## ORIGINATION FORM

### Proposed Revisions to a Standard Plans Index

Index Number: 521-630

Index Title: PARAPET WITH C-I-P SIDEWALK - WALL COPING

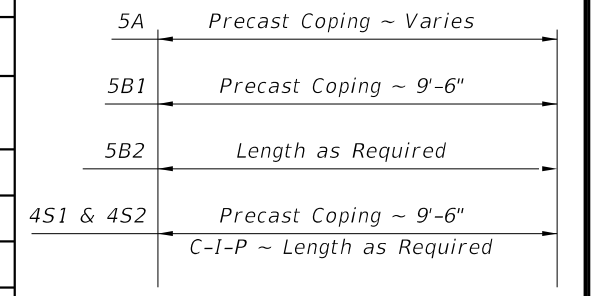
**CHANGED DEPTH TO: 18"**

**UPDATED TO: Shoulder Barrier**

**TYPICAL SECTION THRU PRECAST COPING/PARAPET WITH C-I-P SIDEWALK AND RETAINING WALL (MSE Wall Shown, other Wall Types Similar)**

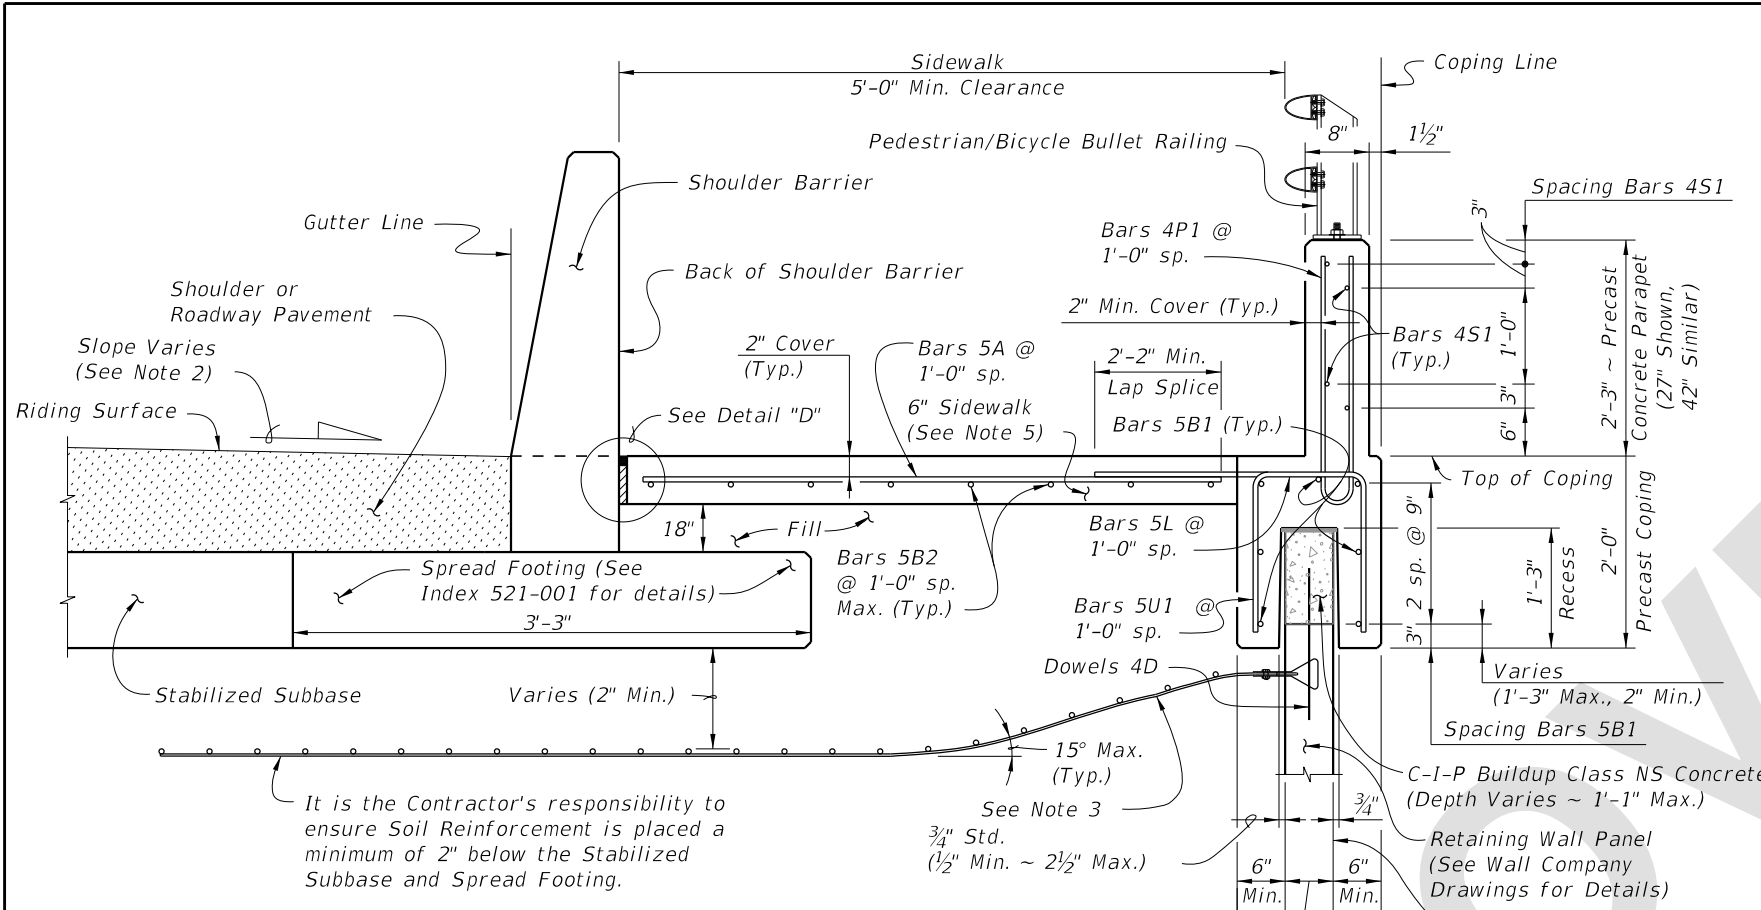
Changed footing depth below sidewalk to 18" from 10"; Updated the name of the barrier to Shoulder Barrier from Concrete Barrier Wall; Changed C-I-P Buildup Concrete (1'-1" Max.) callout in the TYPICAL SECTION THRU PRECAST COPING/PARAPET WITH C-I-P SIDEWALK AND RETAINING WALL to C-I-P Class NS Concrete (1'-1" Max.)

**CHANGED DEPTH TO: 18"**

**ADDED DIMENSION: 3'-3"**

**CHANGED TO: Class NS Concrete**

CIP buildup concrete type was never clarified. SDO review deems Class NS is acceptable because the concrete buildup section is not meant to transfer any meaningful load to the wall other than self weight.
